**EB-2023-0261 Neustadt Community Expansion Project Leave to Construct
Pollution Probe Submission**

**Enbridge Gas Inc.
Neustadt Community Expansion
Leave to Construct**

POLLUTION PROBE SUBMISSION

Figure 1: Pathways to Net Zero Emissions for Ontario ⁴⁴

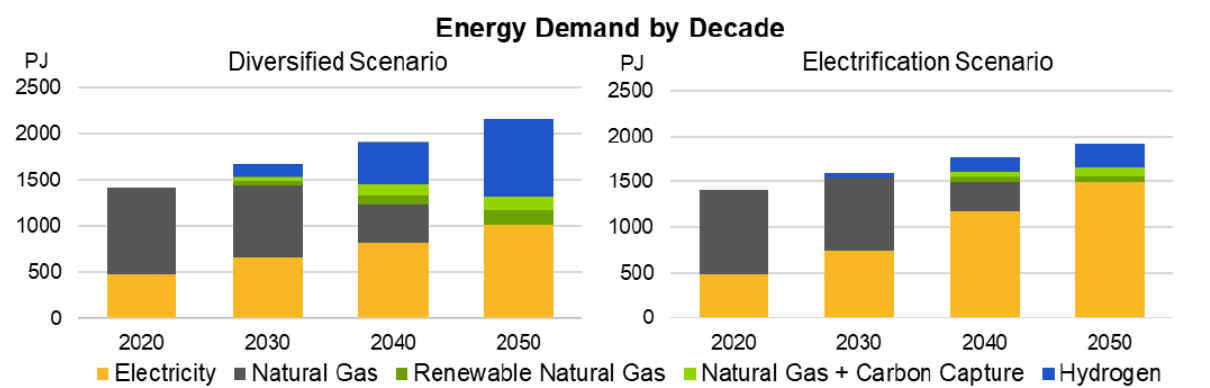
Enbridge recently commissions a study to identify a Diversified Scenario to provide a best-case scenario for natural gas infrastructure between now and 2050 given the Energy Transition to Net Zero emissions pathway in Ontario. If this Project is commissioned in 2025, it would require collection from ratepayers out to 2065 based on a 40 year amortization period and the proposed System Expansion Surcharge proposed for this project. Even under Enbridge's most optimistic Diversified Scenario all customers except potentially the largest industrial customer (if they can install carbon capture and sequestration or CCS) will no longer be using natural gas before the project is fully recovered. Enbridge has confirmed that this project has not been designed or approved for hydrogen⁴³.
